CITY OF MENASHA
Board of Public Works
Third Floor Council Chambers
140 Main Street, Menasha
January 5, 2015
6:30 PM
or immediately following the Common Council

Re: Menasha Utilities
City Of Menasha, Wisconsin
Water Treatment Facility
Low Lift Pump Modifications
Change Order #2 - J.F. Ahern Co.
McM. No. M0002-930724.04

Contract No. M0002-930724
 Project File No. M0002-930724.04
 Change Order No. Two (2)
 Issue Date: November 21, 2014
 Project: Menasha Utilities
Water Treatment Facility
Low Lift Pump Modifications

Contract No. M0002-930724
 Project File No. M0002-930724.04
 Change Order No. Three (3)
 Issue Date: December 12, 2014
 Project: Menasha Utilities
Water Treatment Facility
Low Lift Pump Modifications

PARTIAL INTERMEDIATE LEVEL FRAMING PLAN

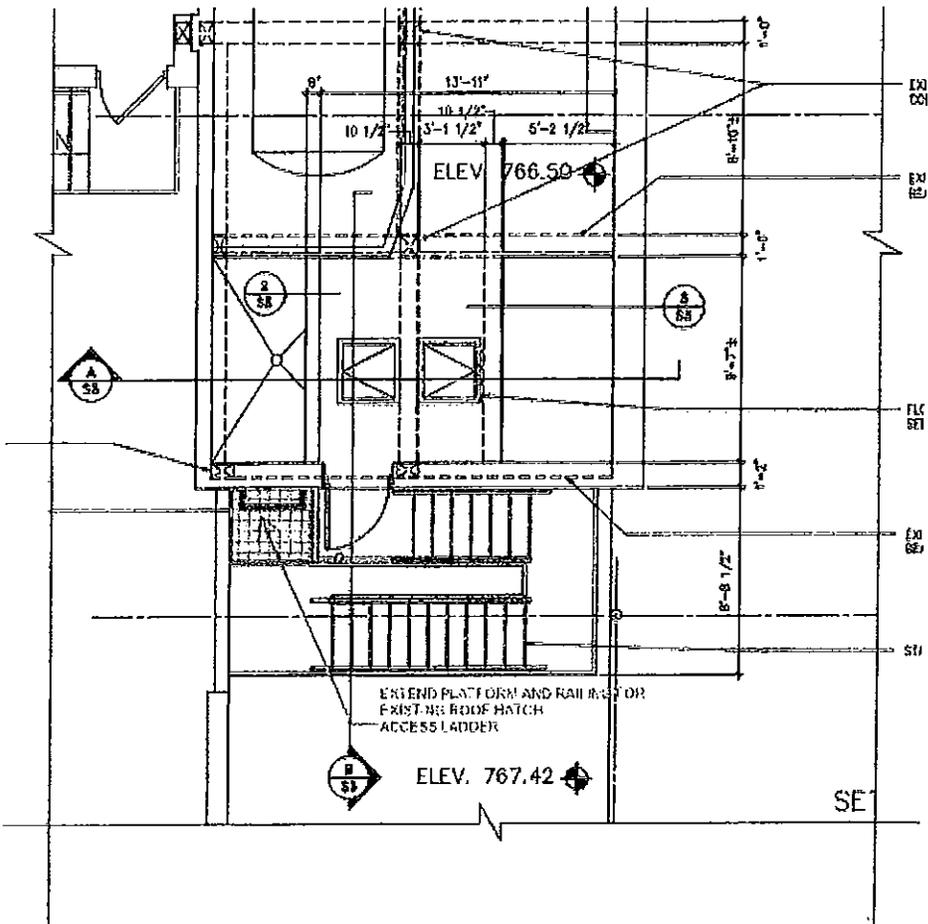
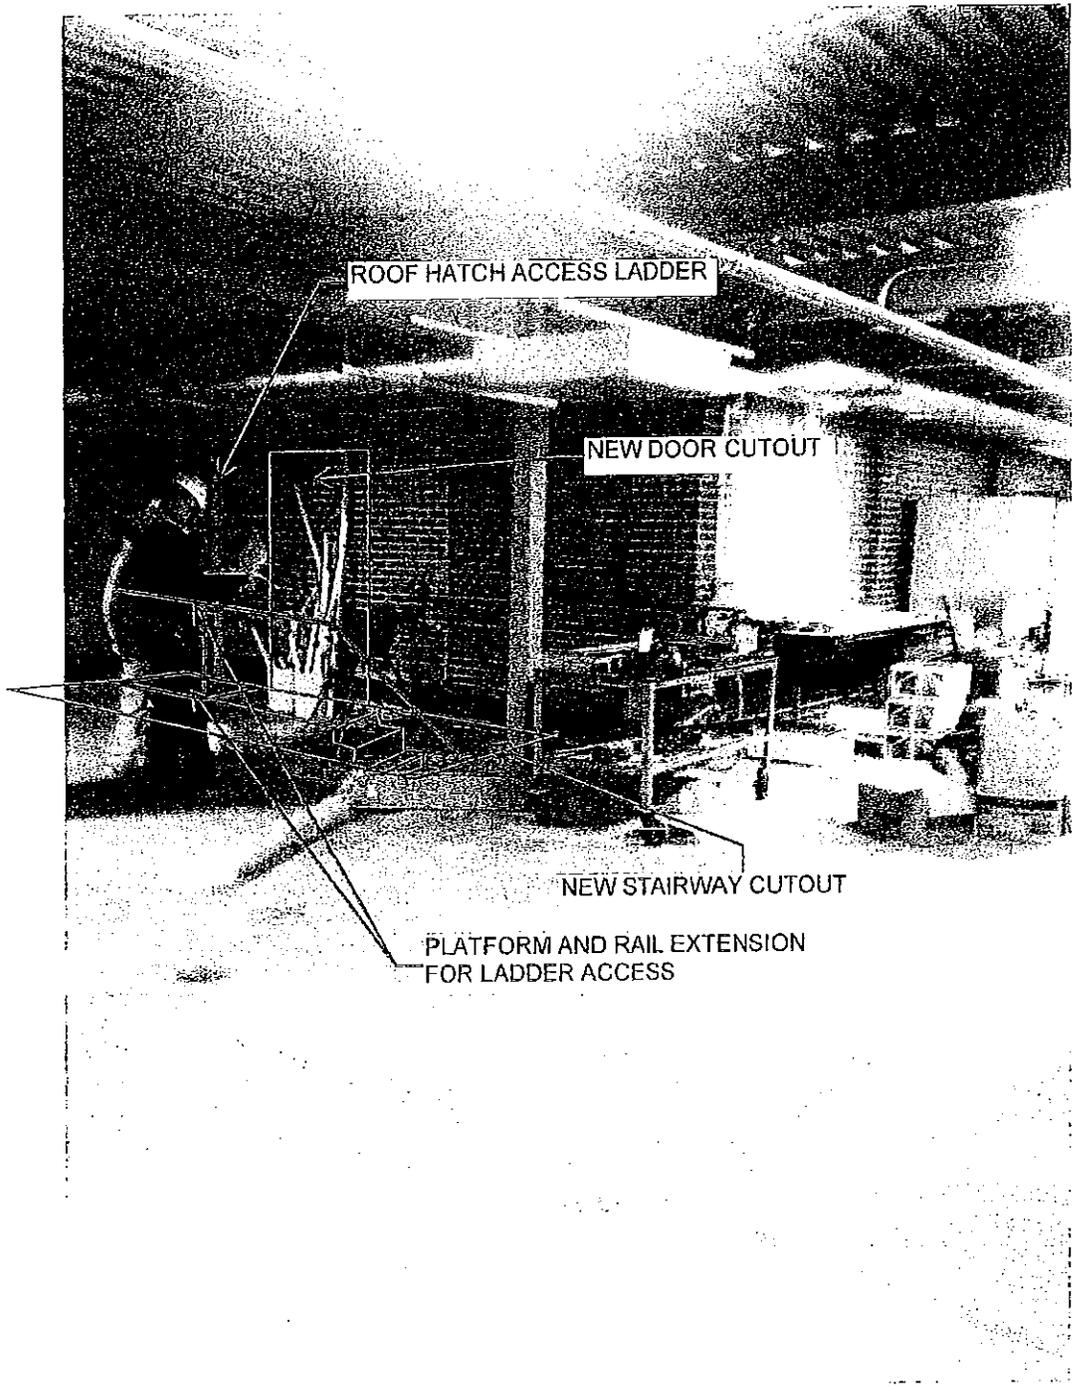
Please verify that that the existing ladder for roof access will need to be provided with a platform extension for access. Cost proposal, drawing and picture are attached for your review.

I found the attached picture showing where the existing precast plank is to be removed for the new stairway. There is an existing ladder for roof access that will need to be provided with a platform extension for access. Below is a layout of what I think Don is looking for.

PLATFORM AND RAIL EXTENSION
FOR LADDER ACCESS

Yes, this platform needs to be extended to the west to provide staff with safe access to the roof access ladder.

Date: 12/10/2014
Project #: 211976
Project Name: Menasha WTF Low Lift Pump Mods
Customer Contract #: M0002-930724
RE: Trough Conflict with 16" Riser
JFA RFI #: 10-0

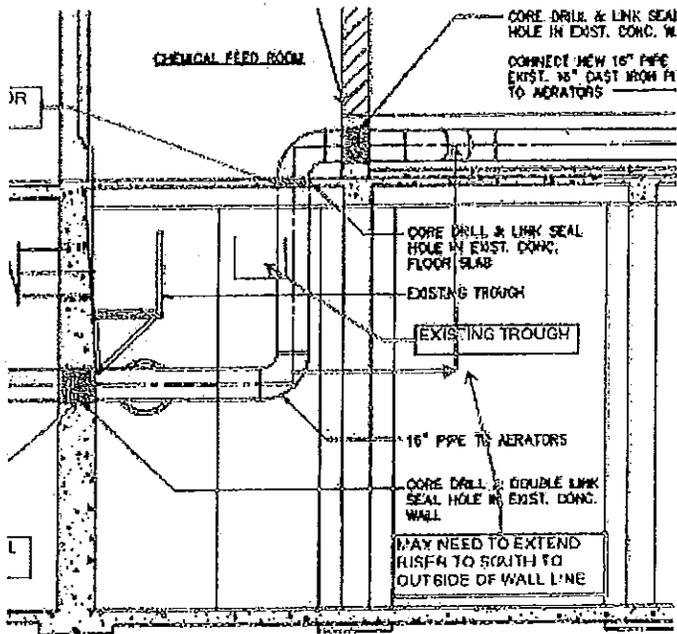
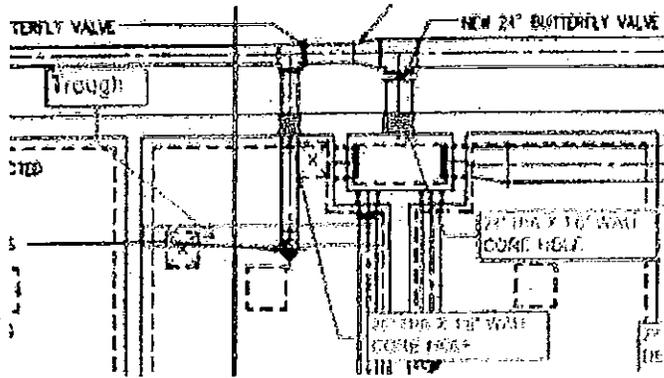
Down in the west basin we discovered a pipe trough which is impacting the 16" riser up to the aeration basin. We may need to extend the riser over to come up in the floor of the aeration basin. We would cut off the upper spool piece and add to the lower horizontal spool either by welding or adding a dresser. We are not sure what the trough is used for; we may need to relocate or revise. Attached is a general sketch of what we discovered.

The trough needs to remain in place as is. Extend 11" piping per your suggestion

Date: 12/10/2014
Project #: 211976
Project Name: Menasha WTF Low Lift Pump Mods
Customer Contract #: M0002-930724
RE: Add Drain to 16" Pipe
JFA RFI #: 11 - 0

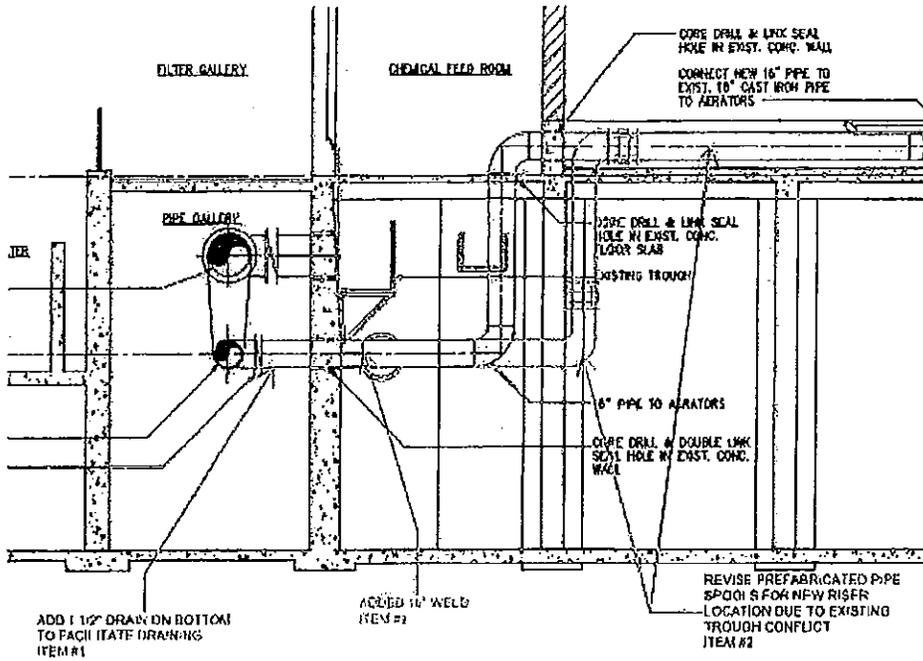
Please confirm that we should add a 1-1/2" drain on the 16" pipe as shown on the attached drawing.

Yes, the owner needs to be able to drain this pipe for winter shut down of the aeration piping
